PARKING ANALYSIS

SADDLE ROCK CROSSING

REVISED 4 JANUARY 2024

**Saddle Rock Crossing PA
Dated 13 September 2021
Comment Resolution**

Figure 3 – Parking Zones

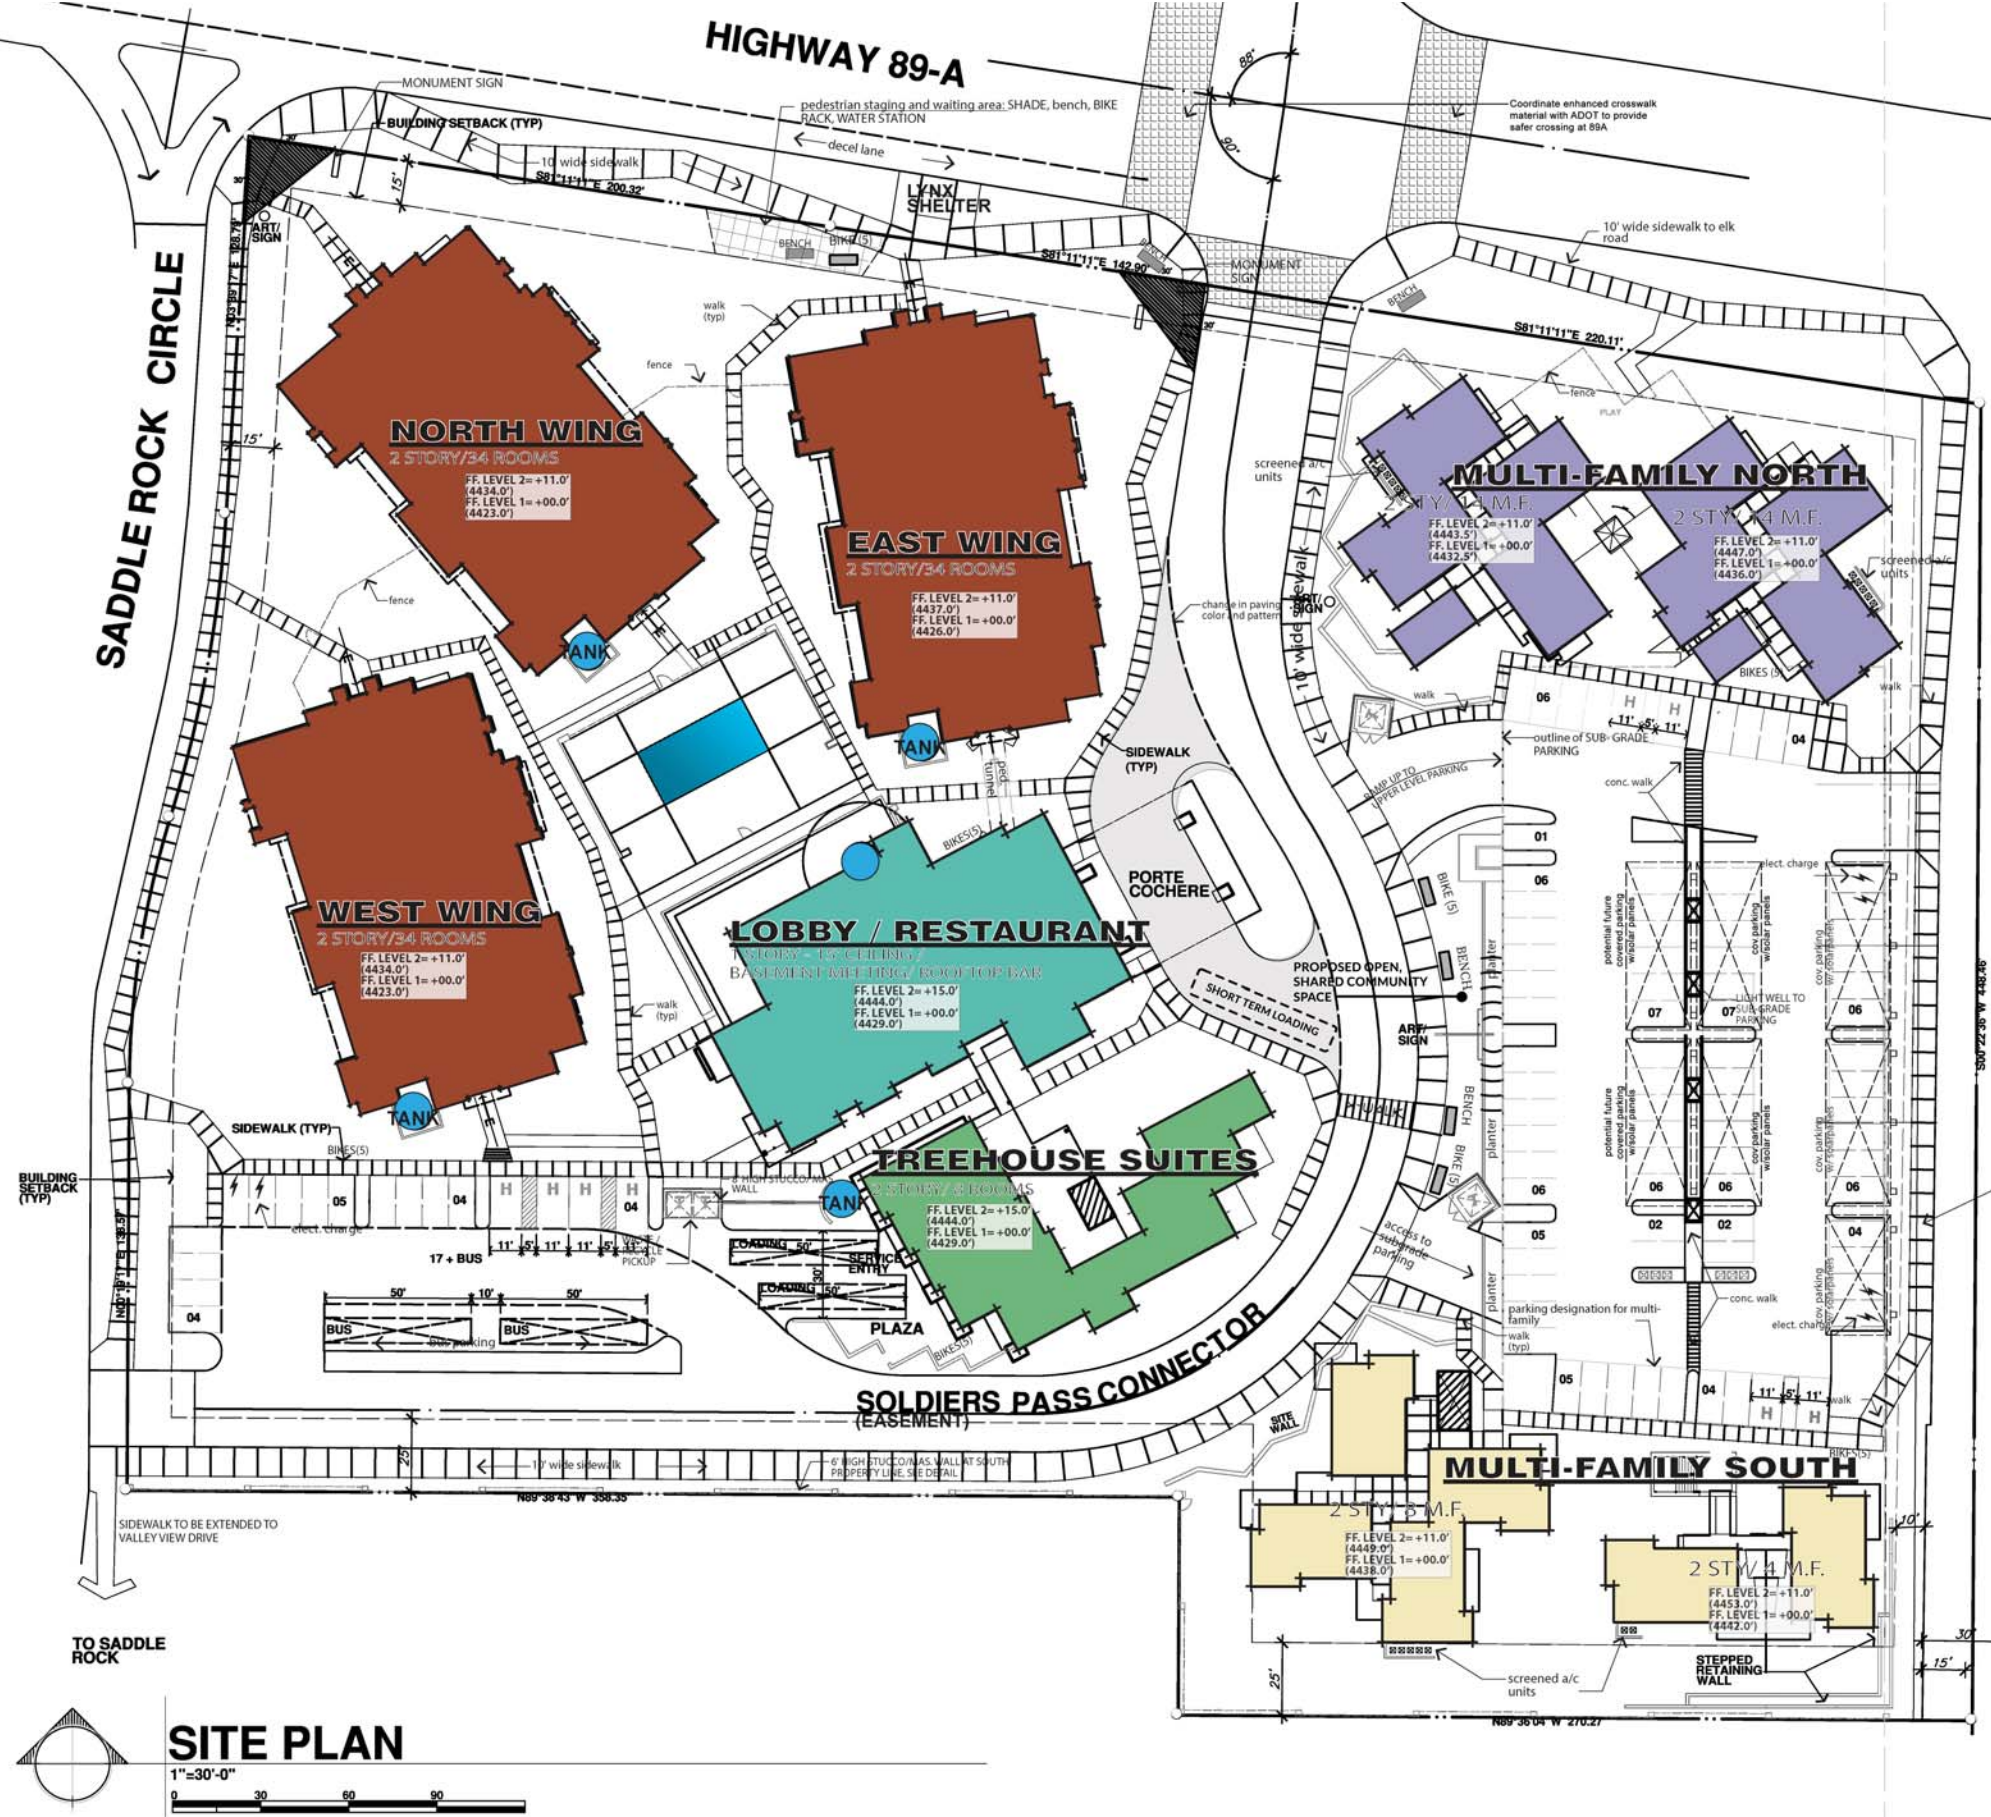
Item No.	Page No.	Reviewer	Code	Comment	Response
City of Sedona					
1	General Comment	Sedona	D	The parking summary and parking study state that 210 parking spaces are provided (177 in parking structure, 21 in surface lot, and 2 bus spaces - counting for 12 spaces). The plans show a total of 198 spaces (165 in parking structure, 21 in surface lot, and 2 bus spaces - counting for 12 spaces). The conclusion of the parking analysis states 125 spaces will be in the structure. Amend appropriate documents so all project components show the same amount of parking being provided.	See revised report.
2	General Comment	Sedona	D	If an accessory use (restaurant, conference center) is 100% used by guests, the parking requirement cannot be "0", as additional staff would be needed for these uses.	The restaurant is expected to mostly be used by hotel guests in the morning. See revised calculation sheet (and report) for employee parking during this time.

3	General Comment	Sedona	A	On the floor plans, clearly indicate which areas are being counted towards as the restaurant area, including outdoor dining spaces.	See revised floor plan.
4	General Comment	Sedona	D	For the rooftop bar, the plans show an area of 1,800 square feet while the parking calculations show an area of 985 square feet. On floor plans, clarify what area is being used for calculations and adjust calculations as needed.	See revised floor plan.
5	General Comment	Sedona	B	Include the total square footage of conference space and include in parking calculation. If the conference space is being proposed for guests only, that would need to be included in the parking analysis, which would propose the appropriate reduction.	The conference space of the hotel will be provided exclusively for hotel guests. This space is typical of hotels and should already be accounted for in parking space requirements for the land use.

6	General Comment	Sedona	A	The plans show 24 studios, 8 1-bedroom units, and 8 2-bedroom units. Amend parking calculations to match the submitted plans.	See revised report.
7	General Comment	Sedona	A	After the parking counts have been updated, update parking analysis to reflect the correct parking requirement, amount of parking provided, and justifications for requested reductions. After a revised analysis has been provided, staff will provide additional comments on the proposed parking reductions. Comments on the current parking analysis are as follows: i) Explain how the 114 hotel units only equate to a parking demand of 23 spaces. Table 3 states that the weekend parking demand would be 1.15 spaces per unit, which would equate to 131 parking spaces, not 23 as stated in the table.	See revised report.
8	General Comment	Sedona	A	If parking reductions are proposed due to hotel guest use of the restaurant and meeting facility, provide methods/strategies to ensure that the property operates as outlined when evaluating the parking reductions.	See revised report.

9	General Comment	Sedona	A	Parking calculations based on area shall be based on gross square footage. Ensure gross area, including restrooms, circulation, etc., are included in parking calculations.	See revised report.
10	General Comment	Sedona	A	Indicate location of bicycle parking on plans. Bicycle parking is required at a rate of 1 bike parking space per 10 vehicle parking spaces. See LDC Section 5.5.D(3) for standards for bicycle parking. Bicycle parking should be provided throughout the site so it is convenient to users of both the multifamily units and hotel.	See revised site plan.
11	General Comment	Sedona	A	Loading spaces are required (LDC 5.5.G). Show location. In addition, the project should anticipate trolleys, jeeps, and/or other tours needing space for pick up/drop off.	See revised site plan.
12	General Comment	Sedona	A	Please offset parking spaces that are at a 90 degree angle to each other to prevent trapping vehicles.	See revised site plan.
